Lower Red Basin Retention (LRBR) Study

Appendix A: HEC-HMS Model Development
Aux Marias Tributary; MB, Canada

**Red River of the North Basin-Wide Modeling Approach
Hydrologic Modeling – HEC-HMS Model Development
Various Tributaries below the Red River of the North at Halstad, MN**

Final Submittal Aux Marias Tributary, MB- Canada

Figure 9: 2002 synthetic event results at Christie gaging station

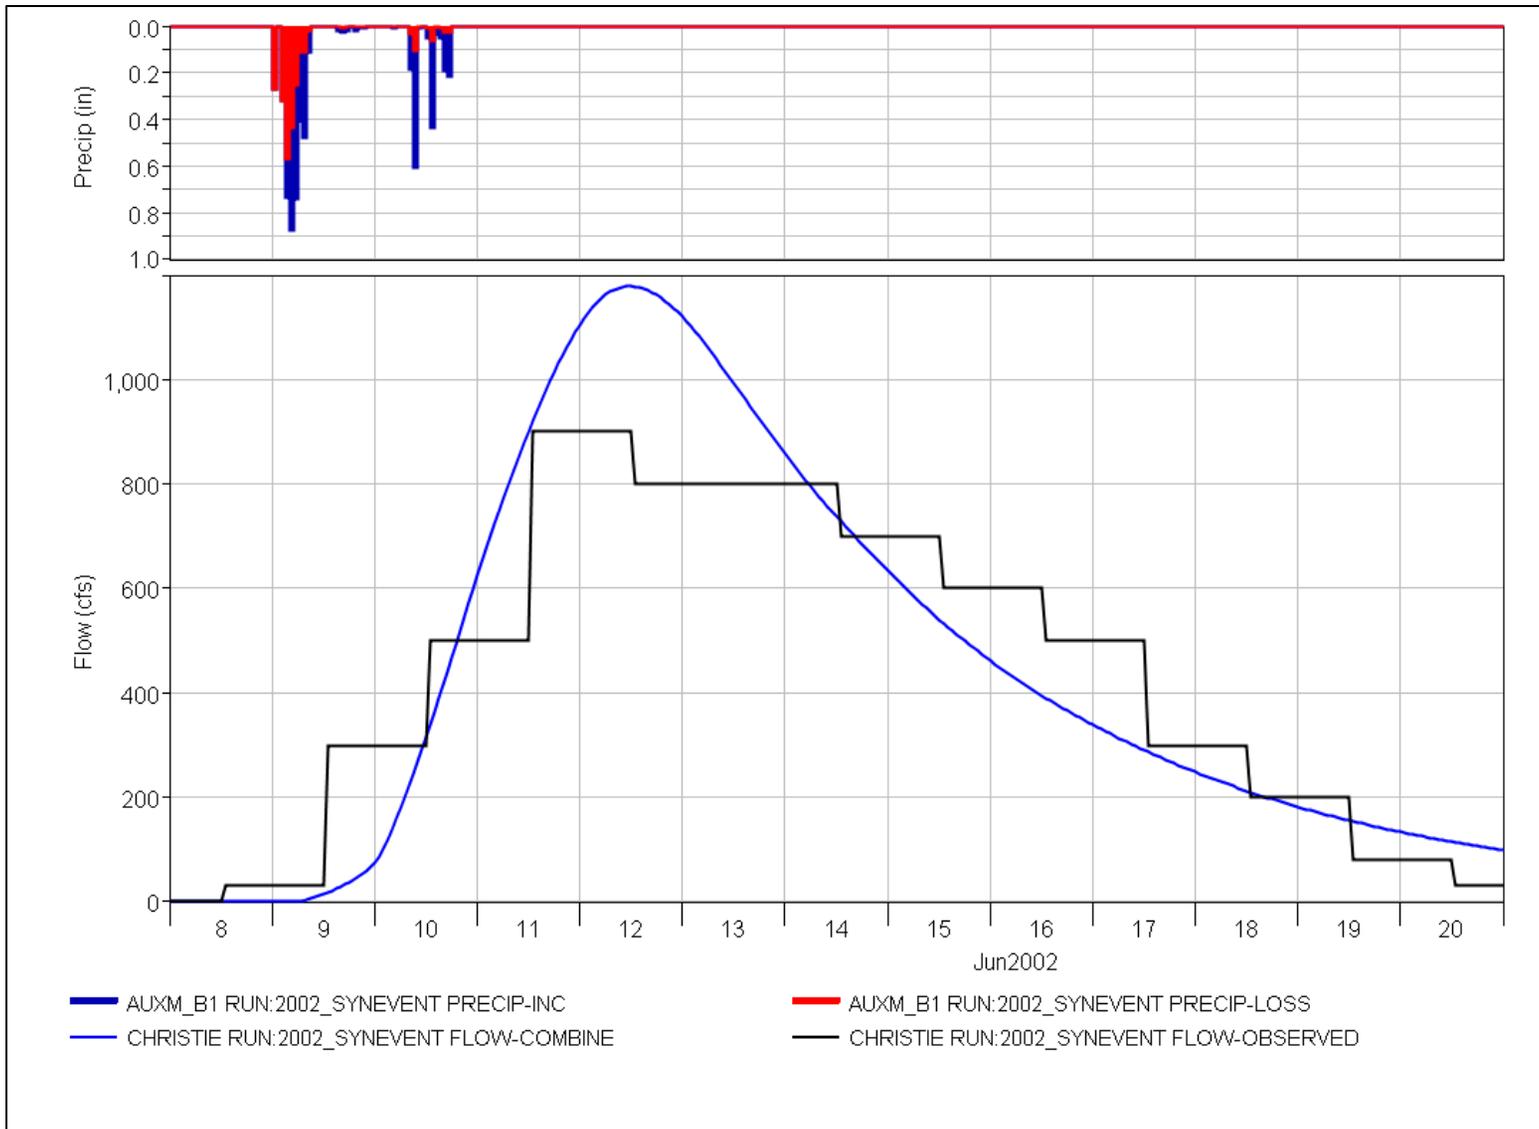
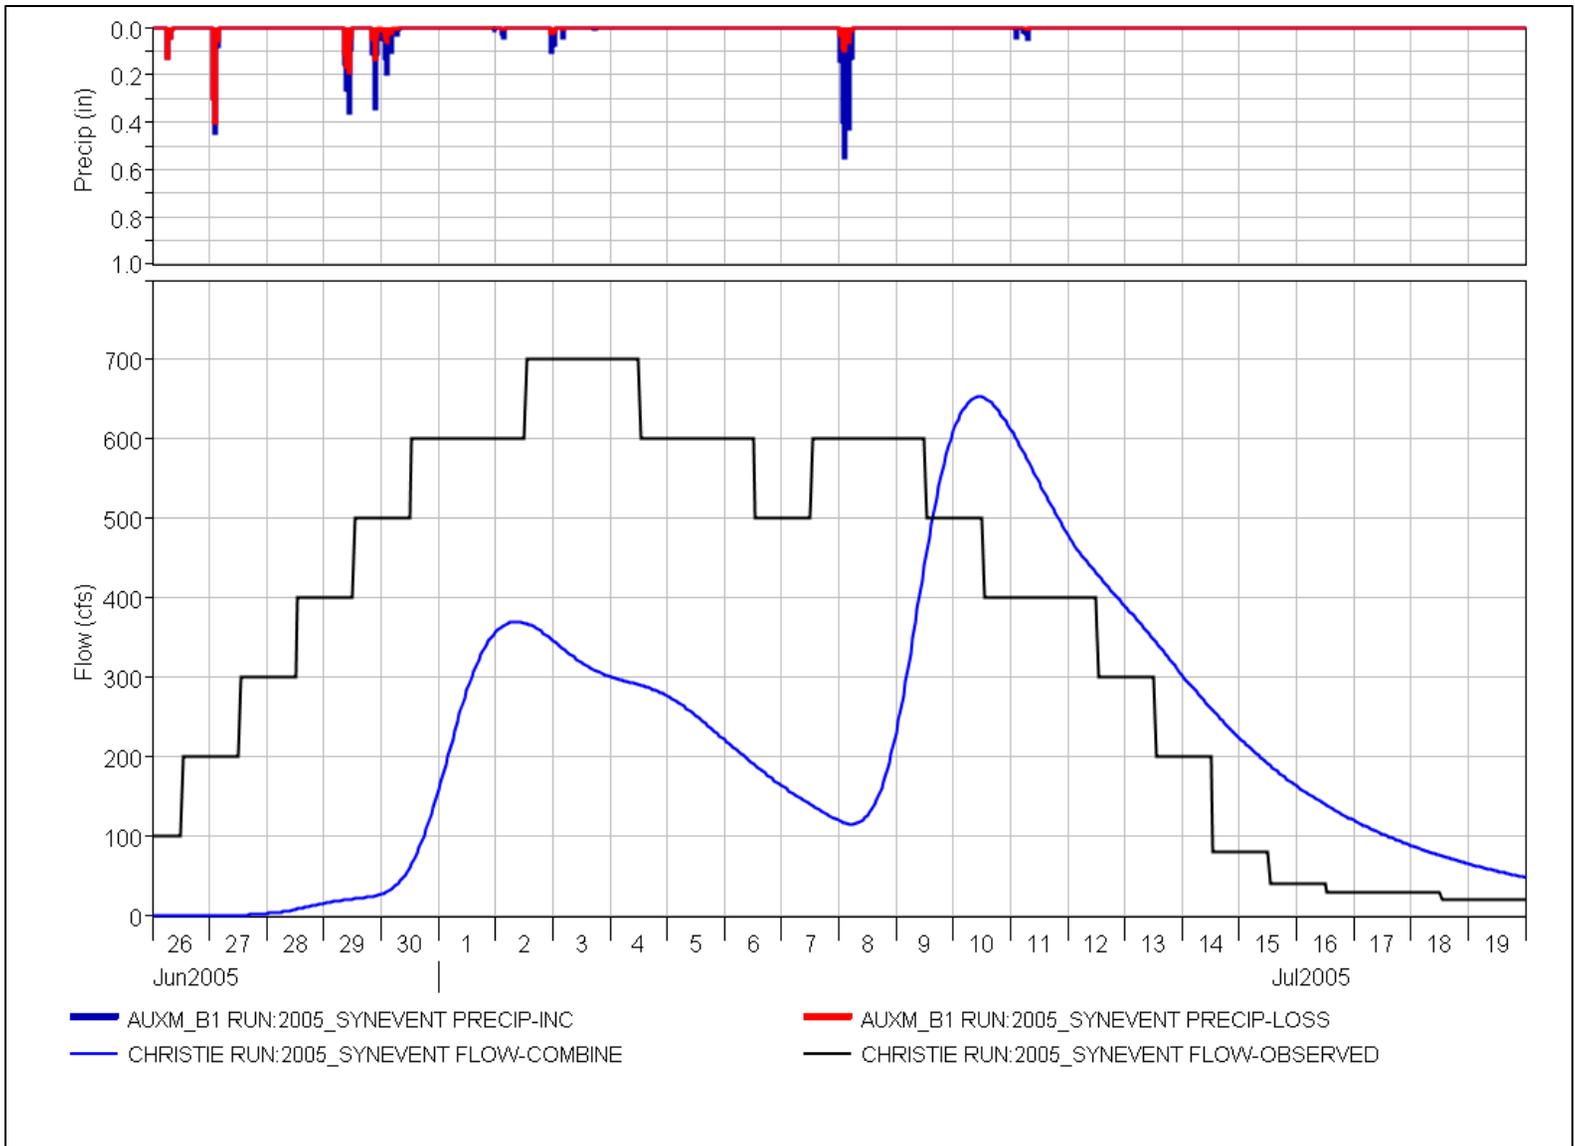
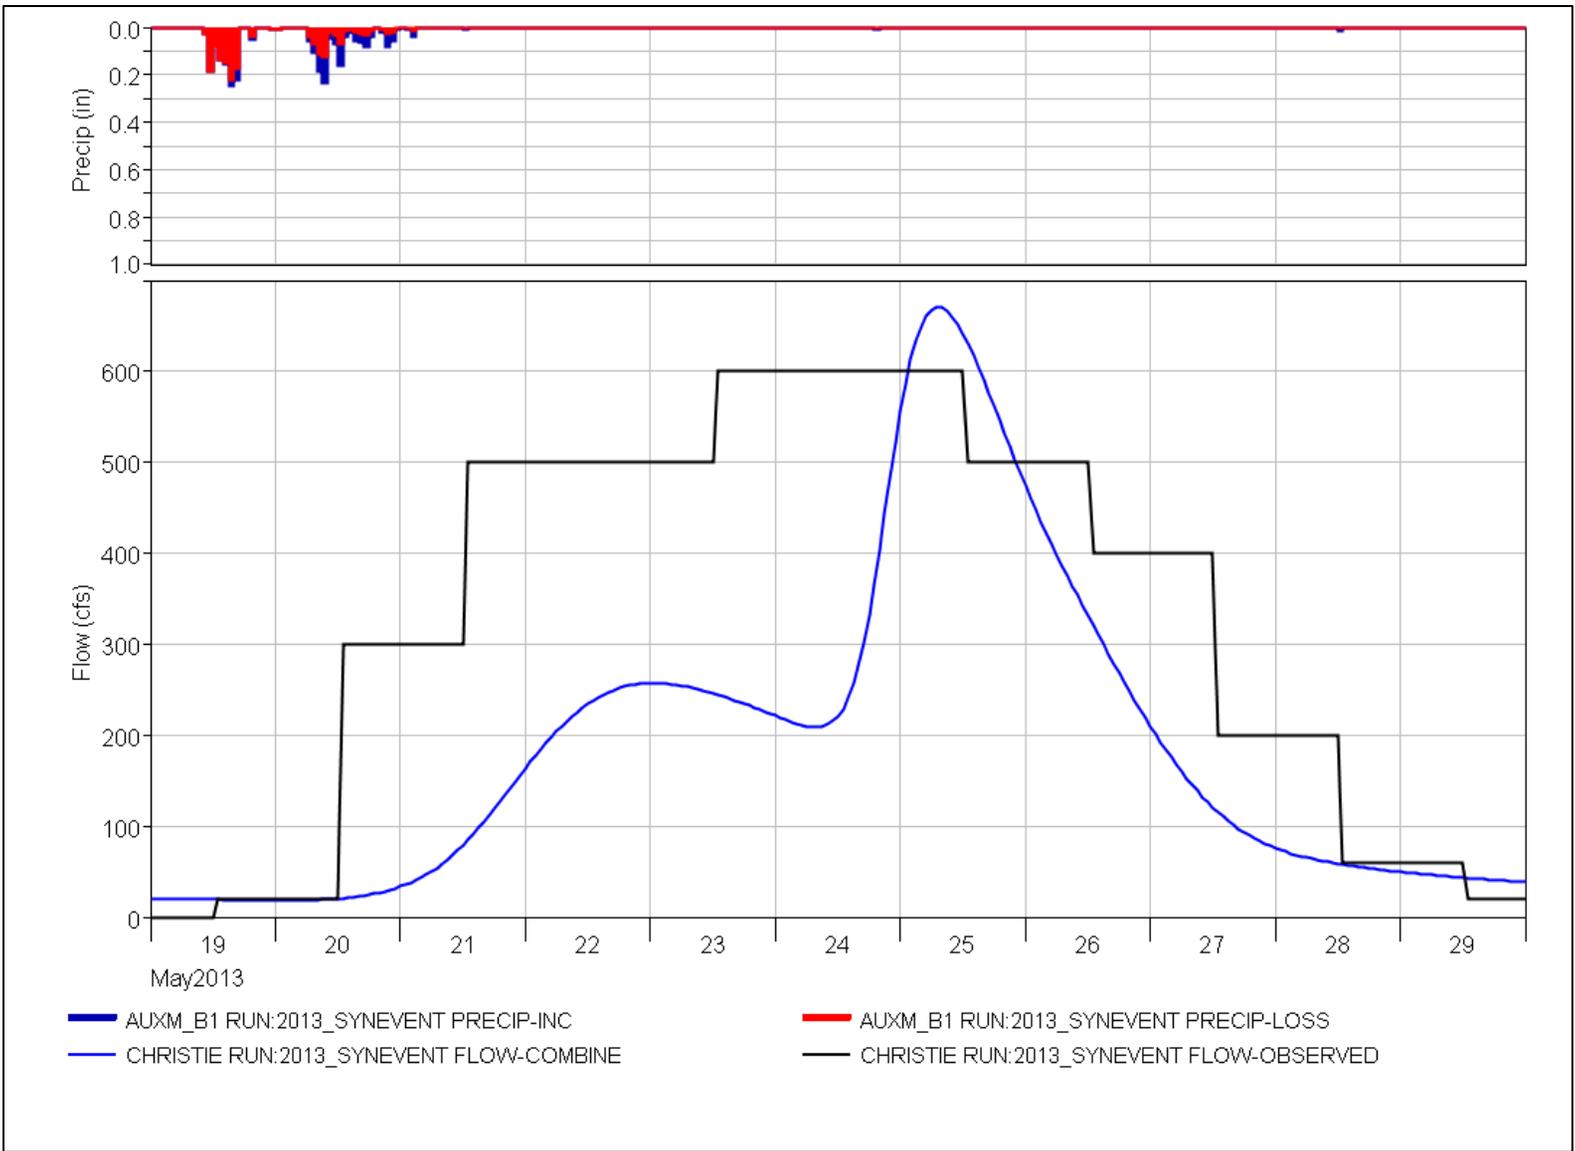
Backcheck Response 1: Note that this is not a true model validation. A true model validation involves running the model, using adopted parameters, for events unique from those used for model calibration. Doing this is likely not possible due to funding constraints. This should be acknowledged in the write-up. Additionally, a table analogous to Table 9 should be generated for model validation or model validation results should be discussed/reflected on in-text.

Backcheck Response 1: CLOSED. Suggested text has been added to the report and a table has been added to the write-up summarizing validation results (Table 11).
